Subject: Indian Point 3 Nuclear Power Plant
Docket No. 50-286
Fire Protection Program Review

SUPPLEMENTAL INFORMATION TO
NRC REQUEST OF SEPTEMBER 29, 1978
AND NOVEMVER 28, 1978 FOR
ADDITIONAL INFORMATION ON
FIRE PROTECTION PROGRAM

POWER AUTHORITY OF THE STATE OF NEW YORK
INDIAN POINT 3 NUCLEAR POWER PLANT
DOCKET NO. 50-286
APRIL 13, 1979

CABLE SPREADING ROOM COMPOSITE PLAN INSTR. BUS & DIESEL GEN. CABLES

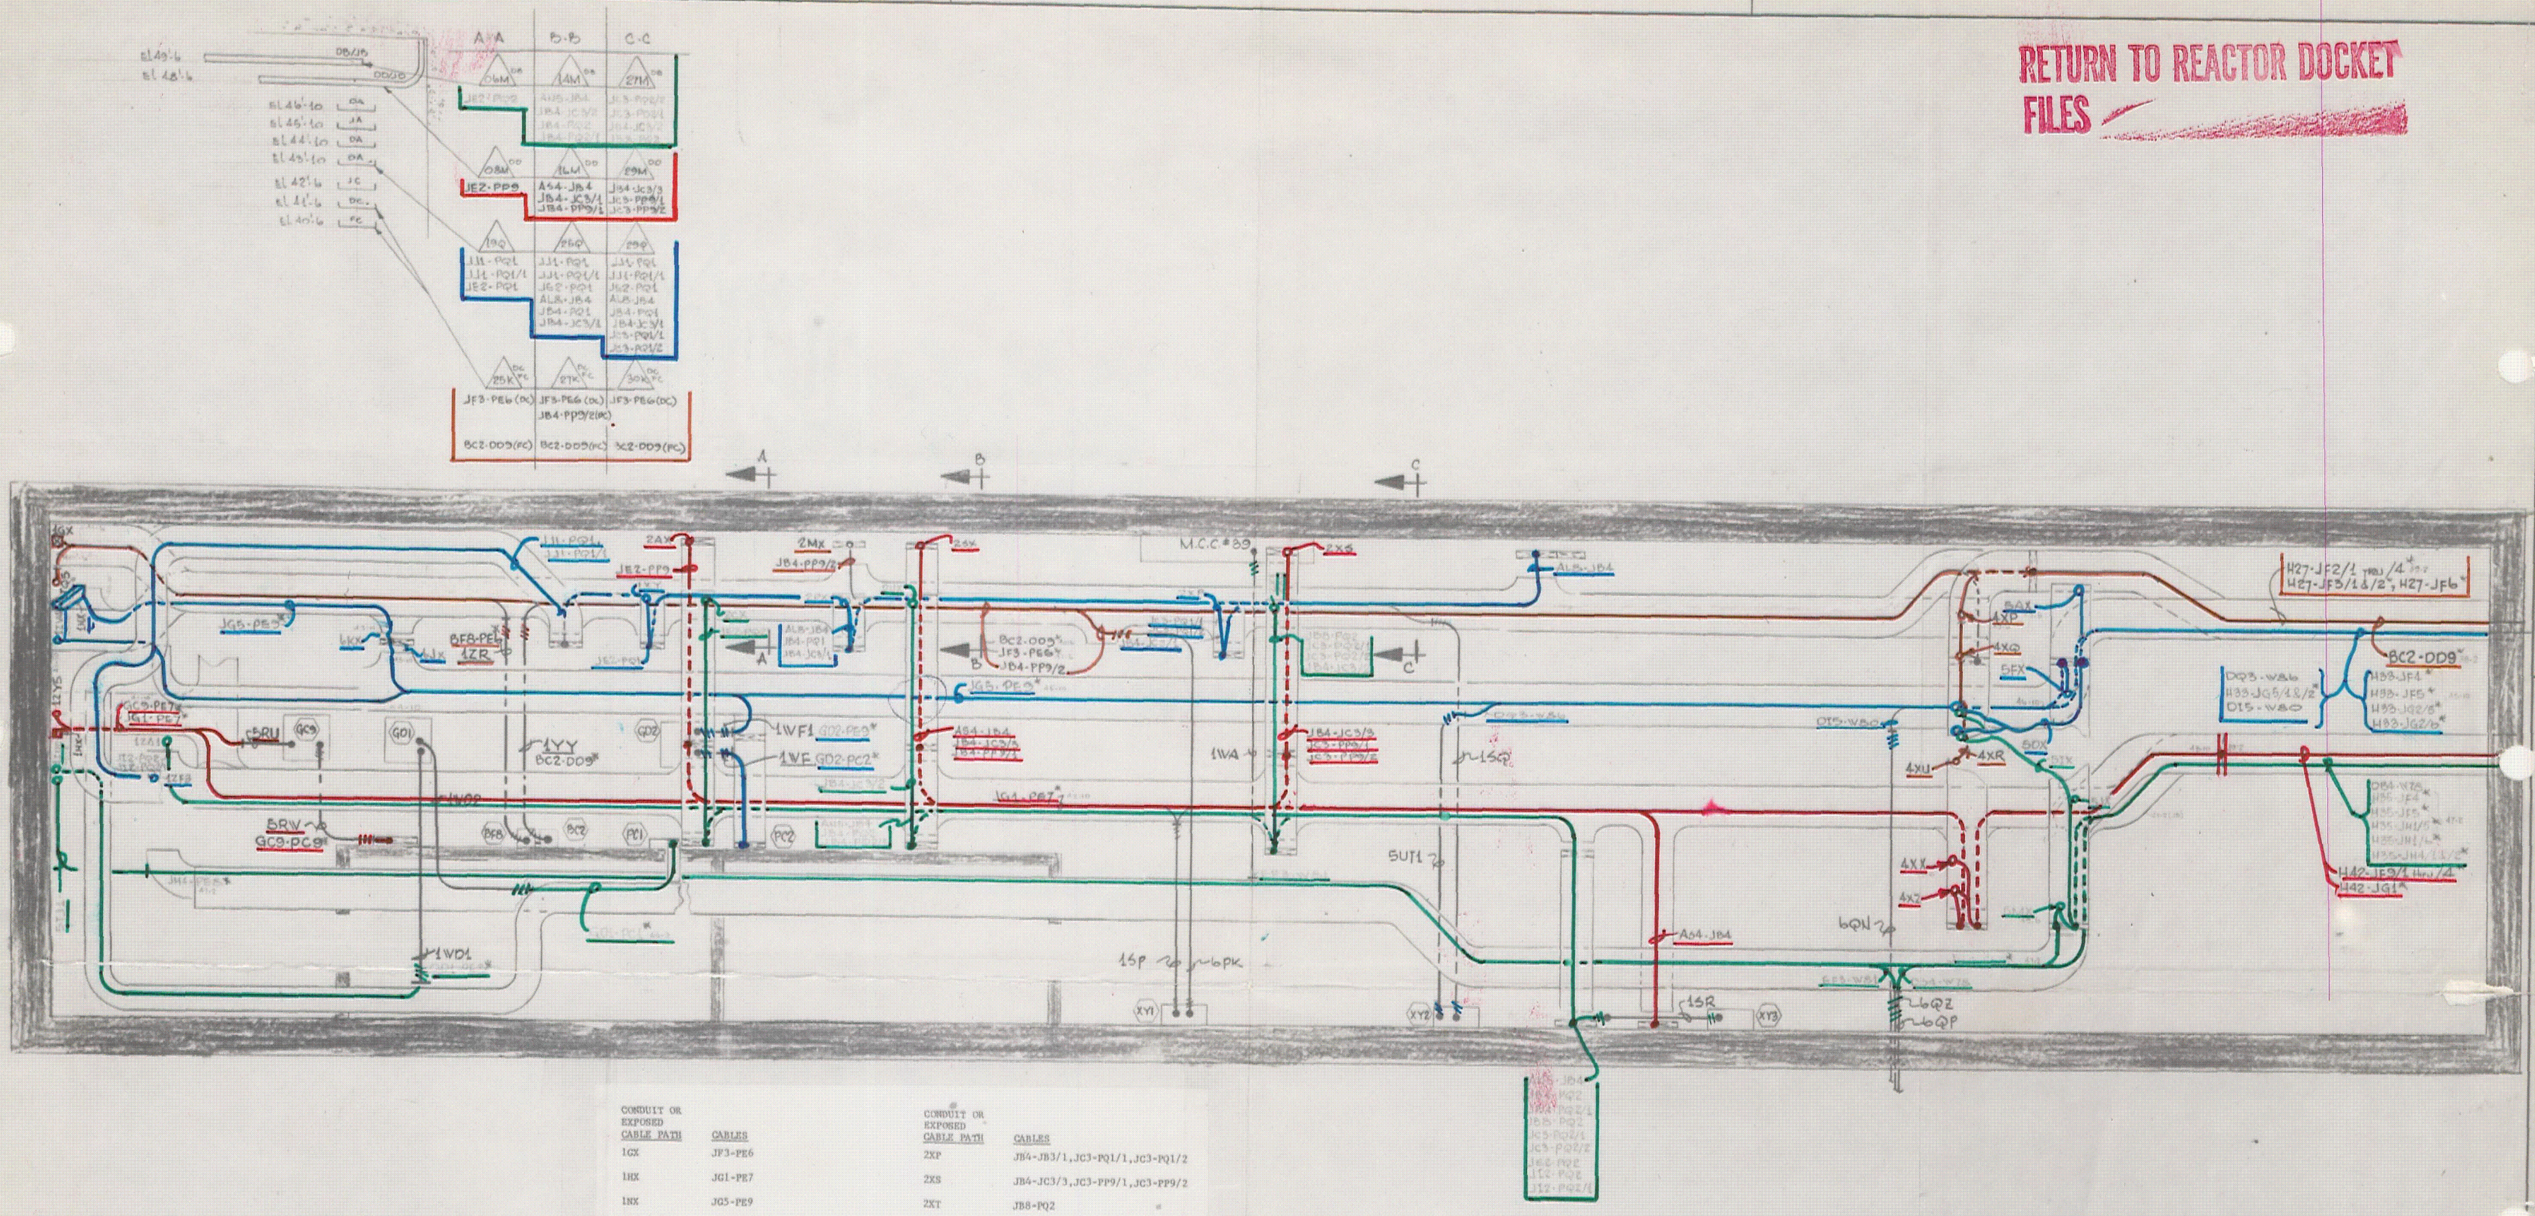
Modifications should be made in the cable spreading room to protect against loss of redundant safe shutdown instrumentation and against the loss of control of redundant diesel generators and the control of the diesel bus breakers from both the control room and local control stations. This could be accomplished by the installation of a sprinkler system in the cable spreading room.

2. Modifications to the safe shutdown instrumentation (pressurizer pressure and level and steam generator level) and to the 31 diesel generator control system should be made to assure that at least one channel of the instrumentation and emergency power to safe shutdown loads is independent of a damaging cable spreading room fire.

The Power Authority of the State of New York (PASNY) has considered the alternatives presented in Staff Position P-15 and has decided to install a CO_2 fire extinguishing system to protect the cables in the cable spreading room. This will be backed by the hose station located Southeast of the cable spreading room outside the door. In order to comply with condition 1 of the Staff Position P-15, the Authority has decided to provide a three hour rated fire wall, (concrete and steel panels filled with silicone foam insulation) which will be constructed across the east end of the cable spreading room so that approximately 20 feet of the power cables will be on the west side of the wall in the cable spreading room area and turn down through the floor to the switchgear room below. The cables in the electrical tunnel area will be protected by the automatic sprinklers. For the extended cables (approx. 20 feet), the Authority has decided to cover trays 18N and 19N with one fire barrier of three hour rated enclosure (proposed material is pyrocrete) from the point of entry of cables from the switchgear room in the floor where it will be totally closed to the point of the entry in the wall where the enclosure will be opened to the tunnel side. This will allow the dissipation of the heat generated in the cables into the tunnel. Similar arrangements will be provided for the 22N tray. In order to comply with condition 2 of the Staff Position P-15 the following modifications will be made to assure that at least one channel of safe shutdown instrumentation and emergency power to safe shutdown loads in independent of the damage in the cable spreading room due to fire.

A means will be provided to completely isolate the control circuits of Diesel Generator #31 and Diesel Generator #31 480 volt circuit breaker from the effects of a cable spreading room fire. This will consist of manually operated switches mounted in cabinets at the diesel generator control panel and the 480 volt switchgear which will disconnect all control wires passing through the cable spreading room area. Local control of the diesel generator will be possible in this mode of operation and will not be affected by a cable spreading room fire.

An instrument panel which will be powered from Diesel Generator #31 via lighting bus 32, will be installed at the end of the tunnel in the penetration area to mount instruments for pressurizer pressure and level and steam generator level. A selector switch will be provided which will select either the control room panel or the new panel. Normally it will be positioned to the control room panel, however, under emergency conditions when normal instrumentation is lost, the operator will go to the selector switch and position it to the new instrument panel. This way one channel of the instrumentation and emergency power to safe shutdown loads will be available independent of any damaging fire in the cable spreading room.

A marked up drawing is attached showing the instrument and power cables routing for Diesel Generator #31.
